BOILER SAFETY REPORT

Nafa Apparels Ltd. 2

Factory ID: 12861

EXECUTIVE SUMMARY

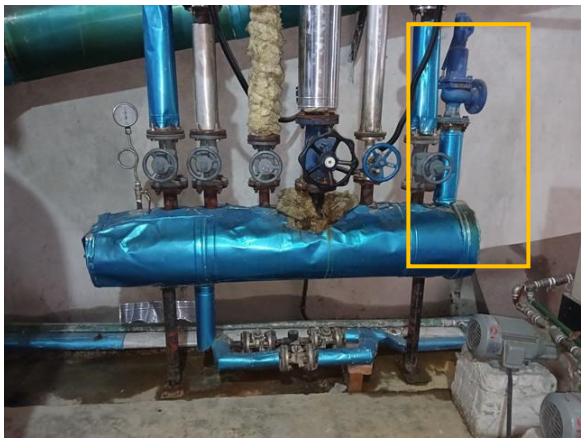
FINDING NO:	B-5
CATEGORY:	SAFETY VALVE
BOILER REGISTRATION NO:	BB 8214
FINDING: Boiler (Steam Header) Safety Valve outlet line was not directed outside of the boiler room.	
RECOMMENDATION: Boiler Safety Valve outlet line should be directed outside of the boiler room with proper support and drainage system.	
PRIORITY:	P2
REMEDIATION TIME FRAME:	1 MONTH

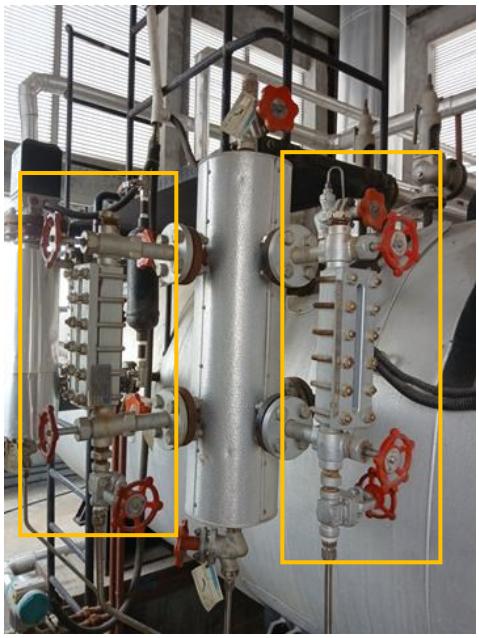
FINDING NO:	B-7
CATEGORY:	MONITORING AND CONTROL SYSTEM
BOILER REGISTRATION NO:	BB 13199
FINDING: Low Low Water Level (LLWL) was not marked properly on water level gauge glass system.	
RECOMMENDATION: The Low Low Water Level (LLWL) should be marked beside the gauge glass on a separate arrangement so that the water level can be visualized and identified clearly.	
PRIORITY:	P3
REMEDIATION TIME FRAME:	2 MONTHS

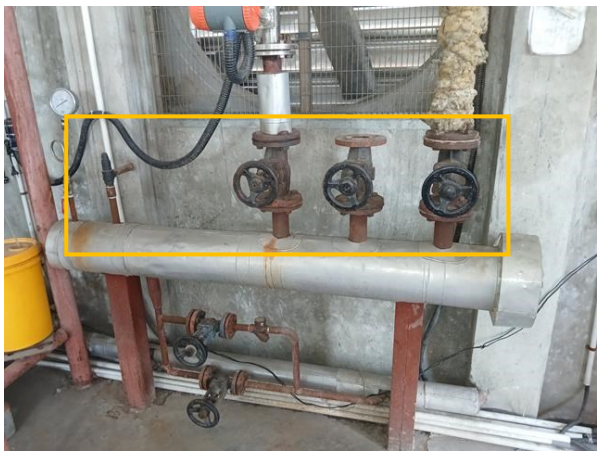
FINDING NO:	B-8
CATEGORY:	THERMAL INSULATION
BOILER REGISTRATION NO:	BB 13199
FINDING: Boiler steam header and steam pipeline were found with improper insulation.	
RECOMMENDATION: Proper insulation to exposed parts of the boiler body and steam distribution pipelines should be provided.	
PRIORITY:	P2
REMEDIATION TIME FRAME:	1 MONTH

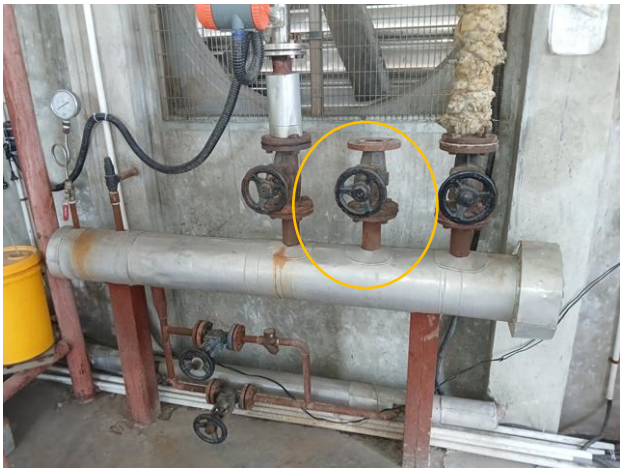
FINDING NO:	B-9
CATEGORY:	STEAM DISTRIBUTION NETWORK
BOILER REGISTRATION NO:	BB 13199
FINDING: Unused steam line connection was not terminated properly.	
RECOMMENDATION: Any unused & unprotective steam line shall be terminated in an appropriate manner that does not create any possibility of burn hazard for the operator(s).	
PRIORITY:	P1
REMEDIATION TIME FRAME:	2 WEEKS

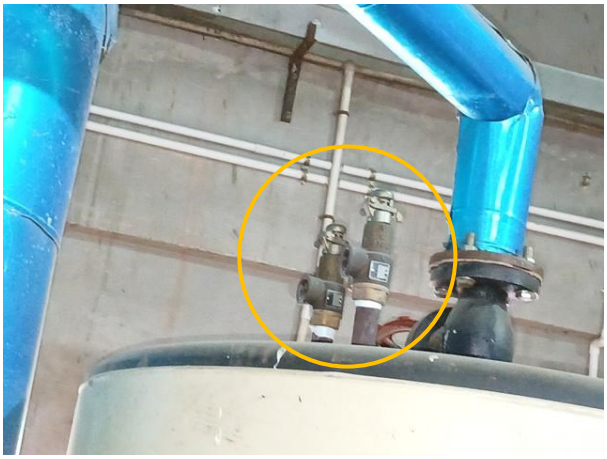
FINDING NO:	B-14
CATEGORY:	SAFETY VALVE
BOILER REGISTRATION NO:	BB 14554
FINDING: Boiler Safety Valve outlet line was not directed outside of the boiler room.	
RECOMMENDATION: Boiler Safety Valve outlet line should be directed outside of the boiler room with proper support and drainage system.	
PRIORITY:	P2
REMEDIATION TIME FRAME:	1 MONTH
